TITLE DRAWING ERRORS ON ONE/SHOT SCHEMATIC/PCBA LAYOUT				PIB NO. DK-3020	
PRODUCT 1001	TAPE DISK FORMATTER	11 XX 11	EQUIPMENT CHANGED 103721/103720 REV. C	MODEL SERIES AFFECTED D3000	EFFECTIVE DATE 1-15-75

**SUBJECT:** D3000 DIABLO COMPATIBLE - DRAWING ERRORS ON ONE/SHOT SCHEMATIC 103720 REV. C and PCBA LAYOUT 103721 REV. C.

PIB NO.  
DK-3020

SCHEMATIC (103720)  
 Zone 8/C

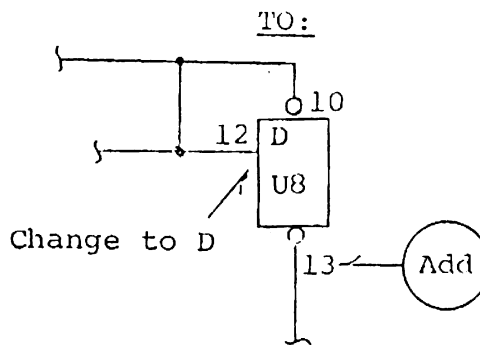
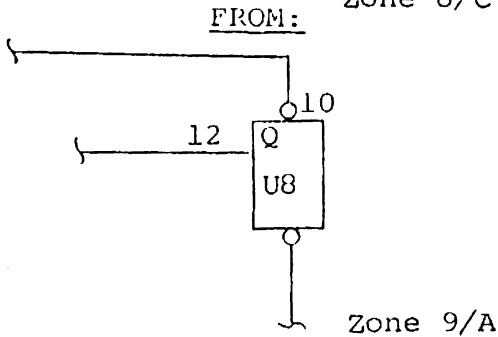
FROM:

TO:

PCBA LAYOUT (103721)  
Zone 7/E

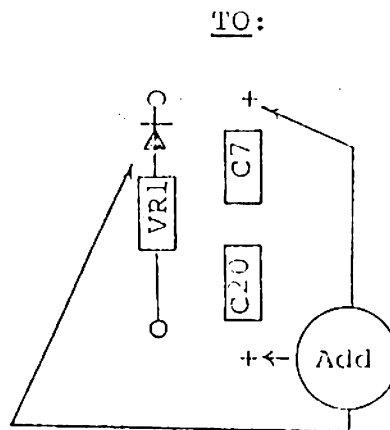
Add polarity signs  
and diodes as shown

Add polarity signs  
and diodes as shown
